Well Name: JAMES RANCH UNIT DI 7 SAWTOOTH	Well Location: T23S / R31E / SEC 6 / LOT 4 / 32.34034 / -103.821955	County or Parish/State: EDDY / NM
Well Number: 802H	Type of Well: OIL WELL	Allottee or Tribe Name:
Lease Number: NMNM02953C	Unit or CA Name: JAMES RANCH UNIT	Unit or CA Number: NMNM70965X
US Well Number:	Operator: XTO PERMIAN OPERATING LLC

Notice of Intent

Sundry ID: 2782126

XTO Permian Operating, LLC. respectfully requests approval to make changes to the approved APD as follows: SHL, FTP, LTP, BHL, change the proposed TVD and update the casing and cement program as follows:

Form C-102
Revised August 1, 2011
Submit one copy to appropriate
District Office

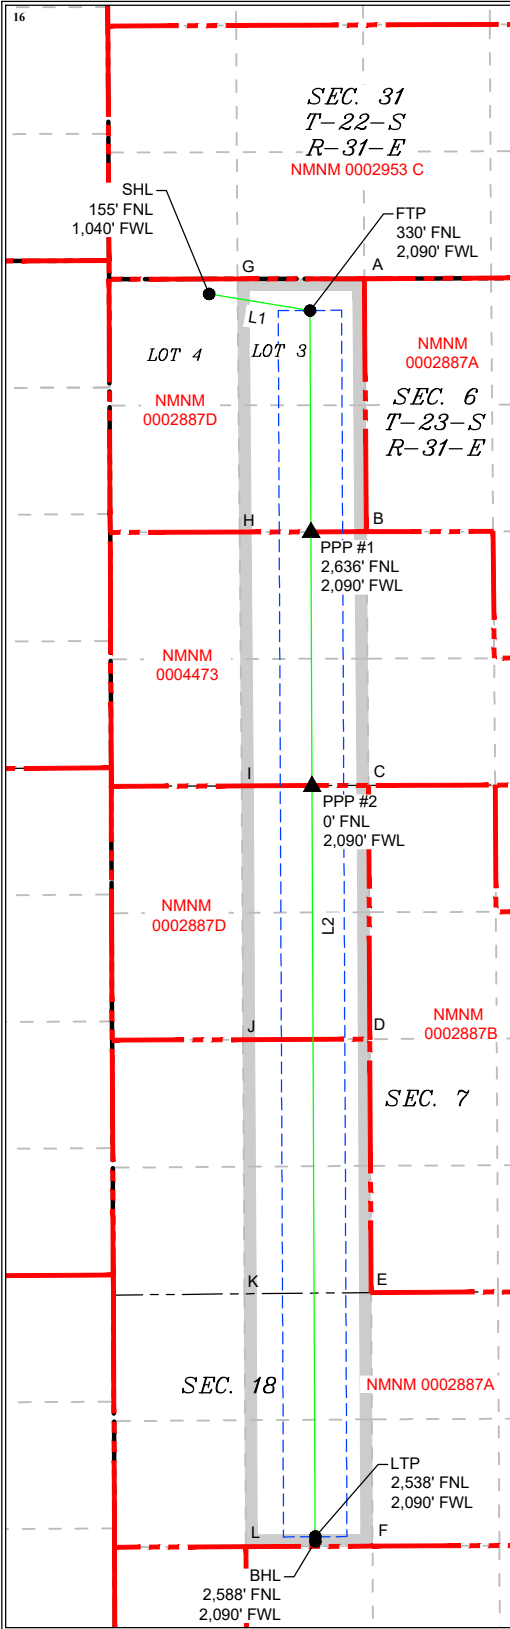
SHL: 155' FNL & 1130' FWL of Section 6-T23S-R31E 155' FNL & 1040' FWL of Section 6-T23S-R31E

FTP: 700' FSL & 1210' FWL of Section 31-T22S-R31E 330' FNL & 2090' FWL of Section 6-T23S-R31E

LTP: 2533' FNL & 1210' FWL of Section 18-T23S-R31E 2538' FNL & 2090' FWL of Section 18-T23S-R31E

BHL: 2583' FNL & 1210' FWL of Section 18-T23S-R31E 2588' FNL & 2090' FWL of Section 18-T23S-R31E
